From: [Craig Burger - DNR](#)
To: ["Herrmann, Dan"](#)
Cc: ["Kubat, Alexis"](#)
Subject: RE: Satterfield 10-2 sundry to vent
Date: Wednesday, May 06, 2015 1:19:00 PM

COGCC doc # 2597158

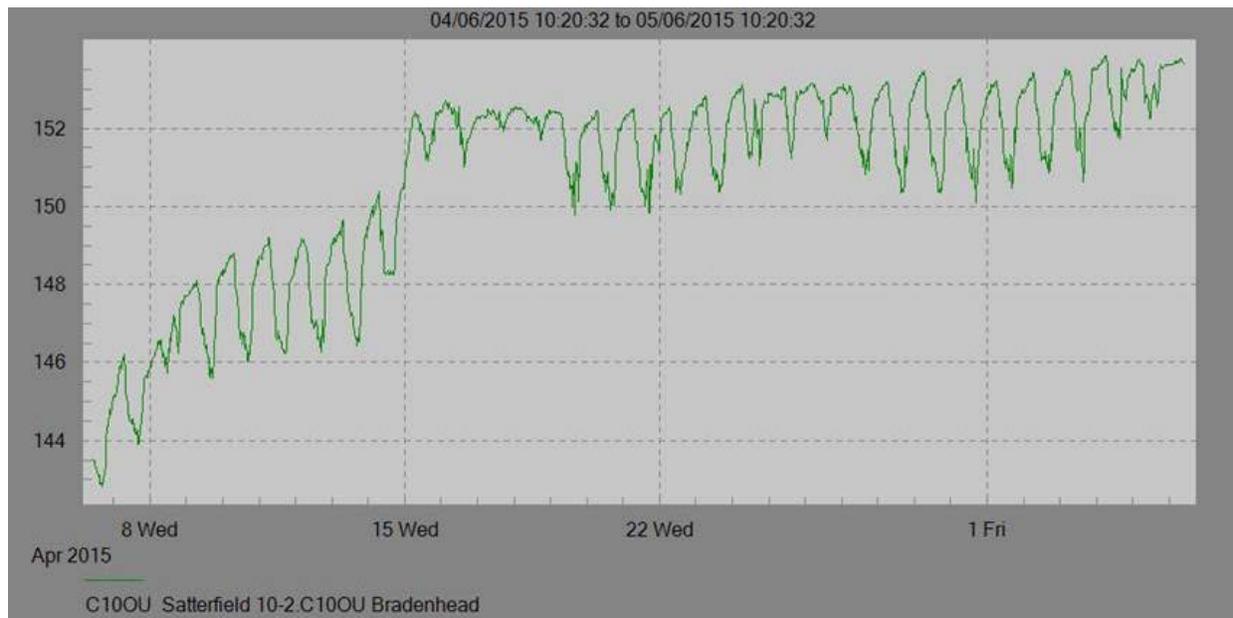
I apologize that I have not followed up sooner, We shut in the Braden head on the C100U Satterfield 10-2. The wellhead has not built to over 154 psi and appears to be flat lined for the last several weeks (I believe the up and down on the graph is due to thermal expansion between night and day), and it appears to be stabilized. If you do not have any issues we will plan to leave the Bradenhead shut in on this well.

Please let myself & Alexis know if you need any further information. The graph below is our SCADA data for the bradenhead pressure.

Dan,
I'm comfortable with this bradenhead remaining shut in.
Thank you,
